Hi-Fi Products
Service Bulletin

Model: TC-W7ES/W9ES/W600/WR700/WR800

No. 76

Subject: High Speed Adjustment Procedure

[AUDIO SYSTEM CONTROL BOARD]

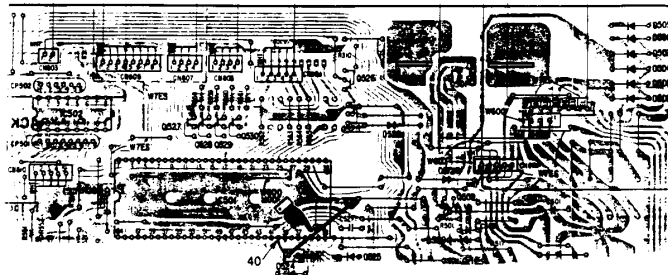
The high speed adjustment procedure, as listed in the manual, is incomplete.

- Solution:**
1. Power down.
 2. Ground Pin 40 of the System Control IC. See table below.
 3. Power Up.
 4. Press and hold the high speed dubbing button, while setting the speed, as per manual specification.
 5. Release it to set the normal speed, as per manual specifications.

Note: High speed must be set first since it will affect low speed adjustment.

Model	System Control Pin #	Connector #
TC-W7ES/W600	40	CN701
TC-W9ES/WR800	40	CN701
TC-WR700	40	CN811
